▶ **FILE #:** 3-C-16-UR

▶ **PROPOSED USE:** Church Parking Lot

▶ **APPROVE** the request for a church parking lot expansion in the R-1 zone, subject to 7 conditions.

**3-C-16-UR
USE ON REVIEW**

A Masterplan for:
Park West Church of God
 7635 Middlebrook Pike
 Knoxville, Tennessee

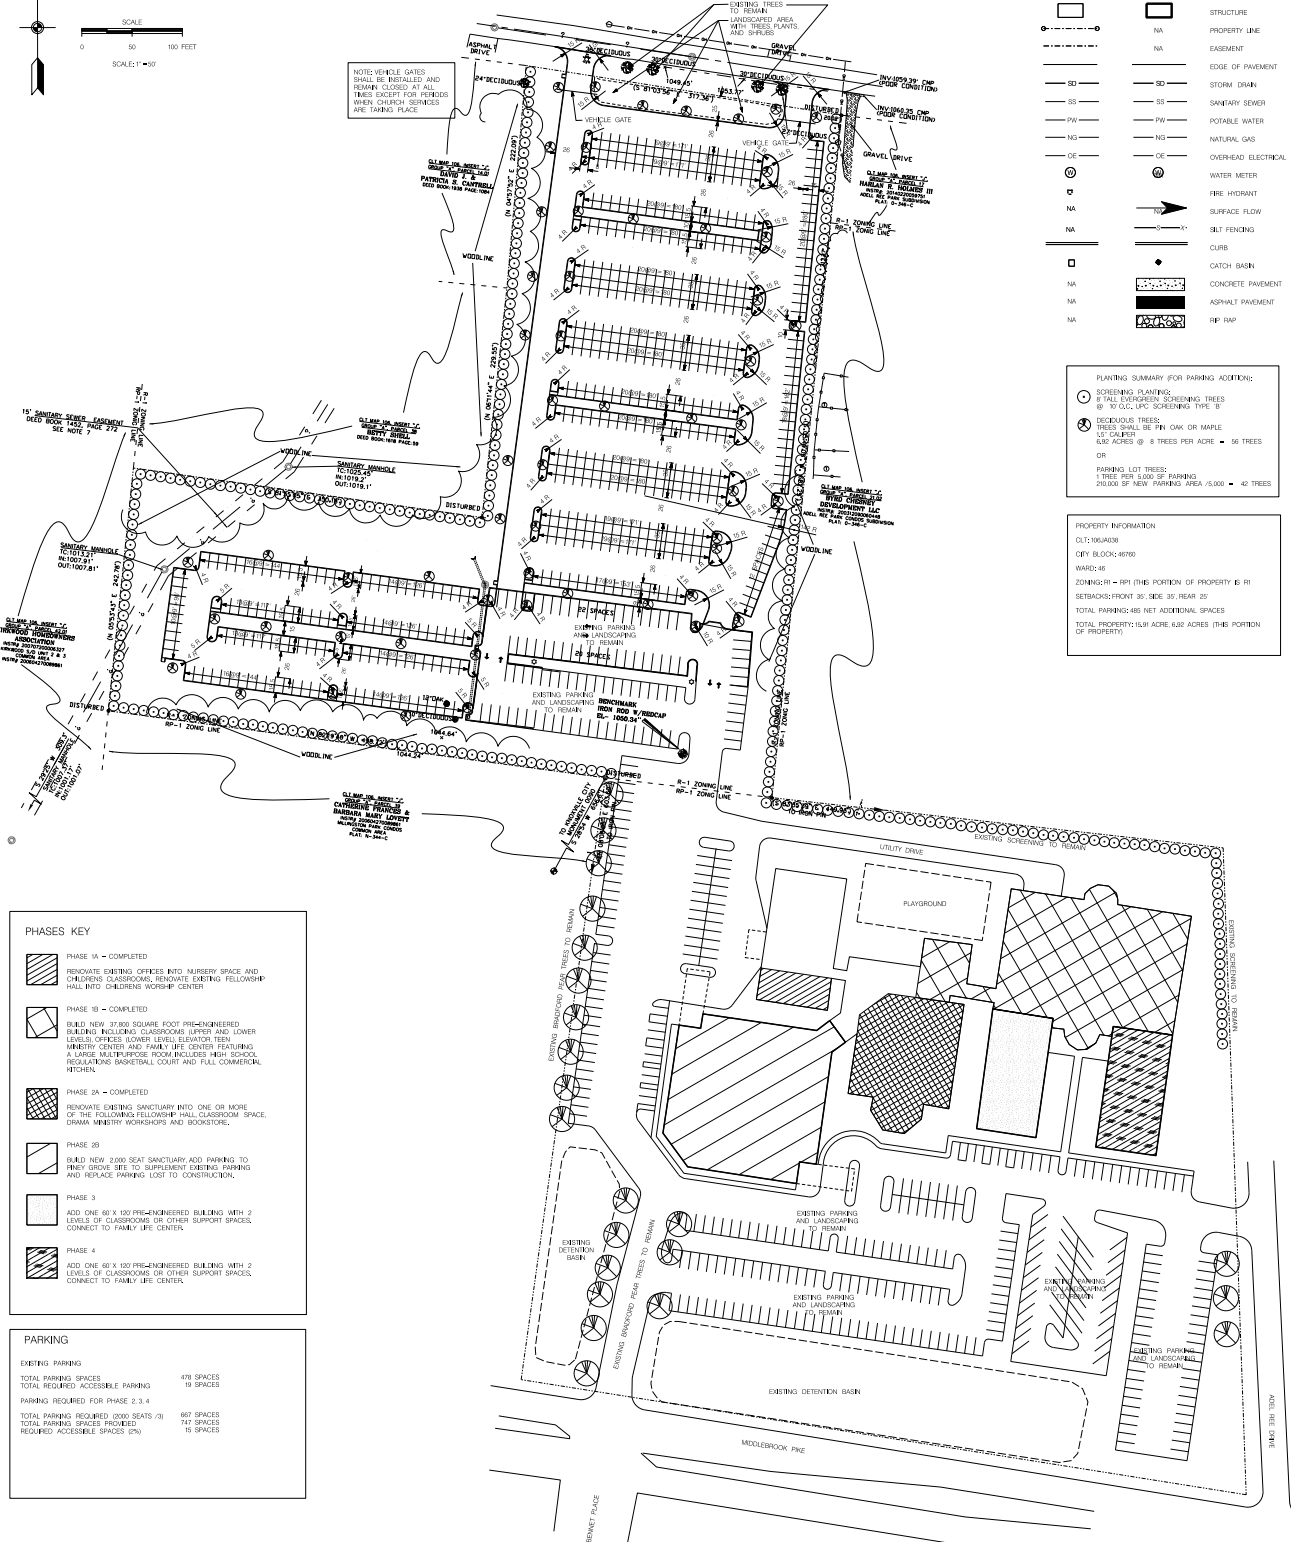
6. The two access points from Piney Grove Church Rd. must be gated at all times except for periods when church services are taking place.
7. Meeting all applicable requirements of the previously approved development plan for the church expansion (11-C-01-UR).

This proposal revises the previously approved development plan from 2001 (11-C-01-UR) by modifying the proposed parking lot north of the church, referred to as the "Piney Grove site". The changes include adding approximately 80 more parking spaces and revising the management of stormwater by removing two detention basins and using pervious pavement in the parking stalls.

1. To reduce cut thru traffic, the two access points from Piney Grove Church Rd. must be gated at all times except for periods when church services are taking place.
2. The plan provides a landscape buffer along the entirety of the property that abuts residential zoning, consistent with a Type "B" landscape screening (see attached).
3. The proposal is compatible with the surrounding development and will improve access to the church by providing an alternative entry point.
